Access Compliance Report

Public Rights-of-Way

Intersection ID: 18214	Main Street: FERNCLIFF_RD	Cross Street: PROVIDENCE_RD	Location: SW
ADA ID: C18A8EA6A8FC	Ramp Type: PerpDiag	Initial Pass/Fail: Fail	Overall Compliance: No
Severity Score: 22.5			
Codes/Mitigation Info/Possible Solution		Field Measurements/Component Compliance

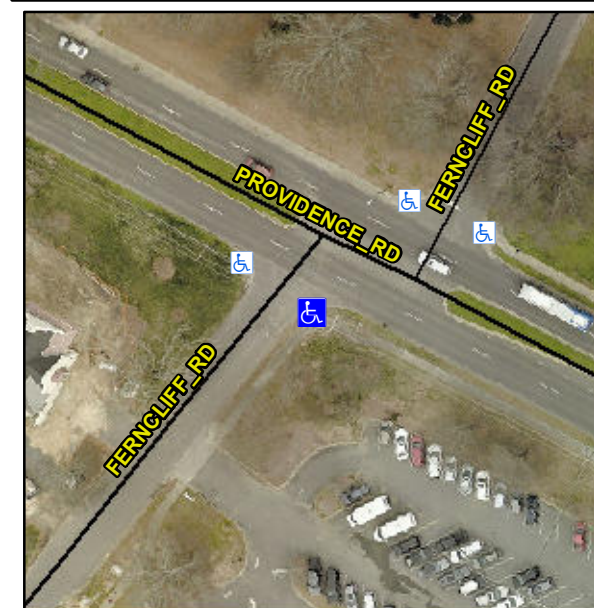
R304.5.1, R304.2.2, R304.5.3

Compliance	Description	Data	Compliance	Description	Data
N/A	Ramp Length (in)	62.0	No	Ramp Slope (%)	9.1
No	Ramp Width (in)	40.0	No	Ramp XSlope (%)	3.0
N/A	Flare Type LT	N/A	N/A	Flare Type RT	N/A
N/A	Flare Slope LT (%)	N/A	N/A	Flare Slope RT (%)	N/A
N/A	Flare Traversable LT?	N/A	N/A	Flare Traversable RT?	N/A
N/A	Landing Length (in)	N/A	N/A	DWS Provided?	N/A
N/A	Landing Width (in)	N/A	N/A	DWS Contrast?	N/A
N/A	Landing Slope (%)	N/A	N/A	DWS Length (in)	N/A
N/A	Landing X Slope (%)	N/A	N/A	DWS Full Width?	N/A
N/A	Landing Curb? (Y/N)	N/A	N/A	DWS Offset (in)	N/A
N/A	Shared Landing?	N/A			
N/A	Gutter Ponding?	N/A	N/A	Gutter Slope (%)	N/A
N/A	Gutter Lip Ht (in)	N/A	N/A	Gutter X Slope (%)	N/A
N/A	Painted X Walk1?	No	N/A	Painted X Walk2?	No
	X Walk 1 Direction	To NE		X Walk 2 Direction	To NW
N/A	X Walk 1 Width (in)	N/A	N/A	X Walk 2 Width (in)	N/A
	X Walk 1 Slope (%)	3.5		X Walk 2 Slope (%)	2.4
	X Walk 1 X Slope (%)	1.3		X Walk 2 X Slope (%)	3.2

Remove & Replace Curb Ramp With Two New Directional Ramps or Equivalent.
